Environmental Assessment Bear Creek Reservoirs Land Management Plan

FINDING OF NO SIGNIFICANT IMPACT (FONSI)

**ENVIRONMENTAL ASSESSMENT
BEAR CREEK RESERVOIRS
LAND MANAGEMENT PLAN**

Figure SRXB-A.3-1: EPU Power/Flow Map with ICA Regions

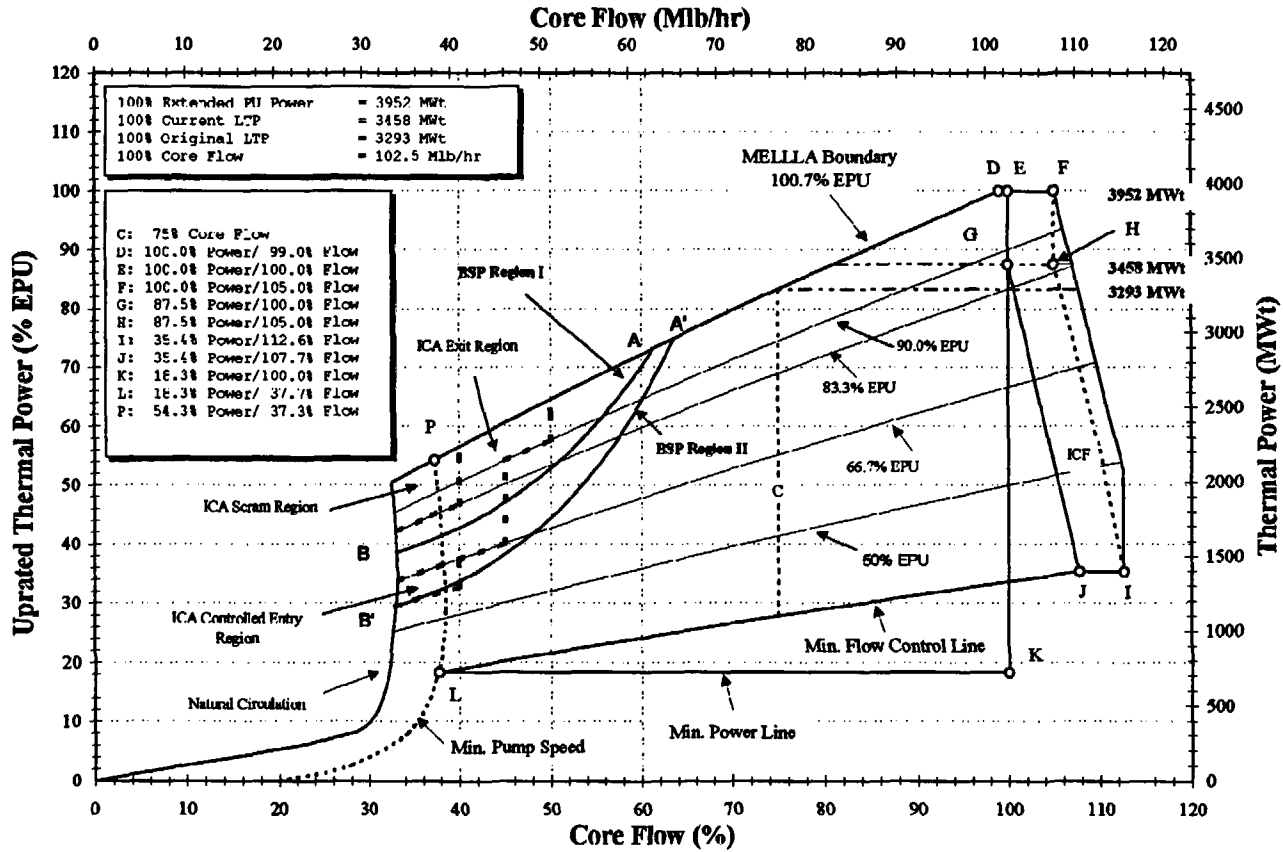
In Section 2.3.1 of the PUSAR, the thermal hydraulic instability exclusion regions are not shown in Figure-2-1. Provide a figure showing the instability exclusion regions.

The thermal-hydraulic exclusion regions are part of the backup stability method used when the Option III system is not operable. Backup Stability Protection (BSP) regions will be established as part of the reload licensing process on a cycle-specific basis in accordance with the guidance provided in

OG02-0119-260, "Backup Stability Protection (BSP) for Inoperable Option III Solution", dated July 17, 2002. Figure SRXB-A.3-1 provides a representation of the BSP regions for reduced feedwater temperature conditions. The original ICA regions, rescaled for EPU conditions, are also shown on this figure for comparison. Normal feedwater temperature BSP regions are typically smaller and the actual size of the BSP regions will vary for each operating cycle.
